North Hertfordshire District Council

Building Conservation comments

File Ref: 24/02804/FPH & 24/02805/LBC

Address: Bibbsworth Hall Farm, Bibbs Hall Lane, Kimpton, Herts SG4 8EN

Insertion of rear dormer window.

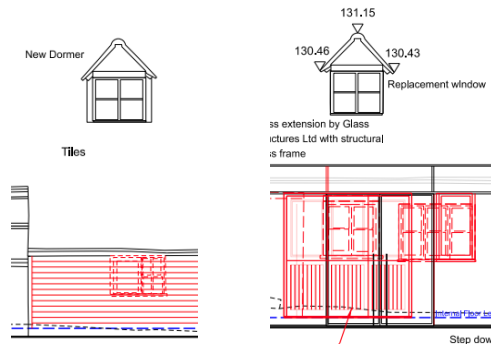
- 4.4 Under appn refs: 23/00558/FPH & 23/00559/LBC I stated the following:

The dormer window in the north (side) elevation would match the existing dormer window in the south (side) elevation and is unobjectionable. My only comment is that both dormer windows could perhaps be improved by introducing a central, horizontal glazing bar to each casement, thus requiring the existing dormer window casements to be remade.

- 4.5 At my site visit on 11 February 2025 I noted that not only had the existing rear dormer already been removed but this, together with the new dormer on the north roof slope were in fact wider, with black framed casements, modern ironmongery and no central horizontal glazing bar (currently indicated on the submitted plans). The casements are 1100mm wide x 770mm tall as opposed to what is shown on the drawings as 950mm wide x 800mm tall. The installed windows therefore have more landscape proportions than what is shown on the drawings which is disappointing.

- 4.6 The dormer construction may not itself be so harmful as to merit an objection but the drawings should be revised to take account of the window proportions. However, the casements lack the quality required for this grade II listed building. What is sought is either single-glazed, traditionally puttied windows or slimlite double-glazed units that are externally compound putty glazed. Either version should ideally have white-painted timber units with appropriate ironmongery.

- 5.1 It is assumed that with works having already commenced that the standard time condition would not be imposed on these applications.
- 5.2 The question is whether the decision is taken to impose a condition requiring the replacement of the dormer casement windows. If so, then I suggest the following:
1. Joinery details incorporating a single, horizontal glazing bar for the double-casements in the two dormer windows on the rear wing and window ironmongery shall be submitted to and approved in writing by the Local Planning Authority within 3 months of the date of this decision notice.

2. Within 6 months of the approval of Condition 1, the unauthorised, black-framed casements shall be removed and replaced with white-painted casements incorporating the approved joinery/ironmongery details of Condition 1.

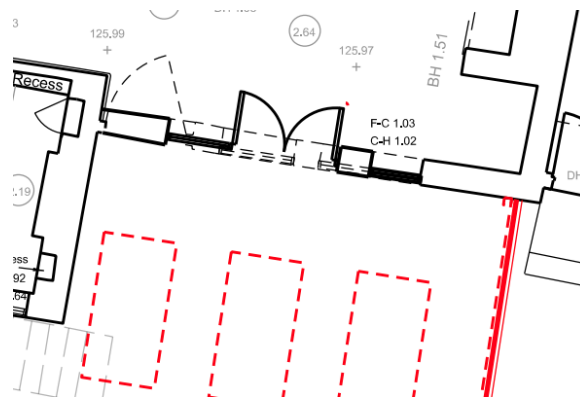
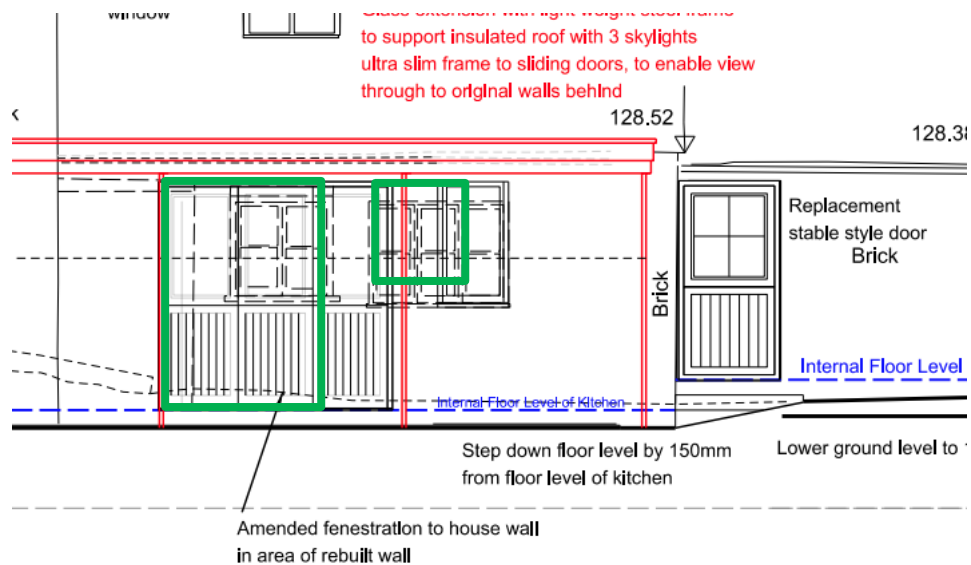
- 4.9 One significant alteration that has already been undertaken is to the south-facing wall/fenestration of the rear wing where two windows and an external door together with brickwork have been removed. I note the following in the submitted Planning and Heritage Statement:

The applicant found that the brickwork in the area of the original kitchen door was in very poor condition and not providing adequate support for the roof structure above, so the decision was made to increase the size of the pier, and reduce the number of openings to a larger door set and one single window. These will be external doors and windows leading to the glazed garden room, beyond.

- 4.10 It is disappointing to see this work undertaken without prior discussion and, importantly, agreement from the LPA. Having said that and had this been so, I may have still considered a larger opening to potentially be a way forward if convincingly justified but I am unconvinced of the approach currently shown i.e. pair of half-glazed doors with a matching fixed panel to the side and a deep single casement with no glazing bar. Reinstating a pair of less deep casements with a single horizontal bar and reducing the main opening to a pair of part-glazed doors with may be only the lower third being a solid panel of the style shown would be a better outcome (green outline below). In my opinion, this aspect of the scheme has a mildly erosive quality, and further discussion should take place on this matter.
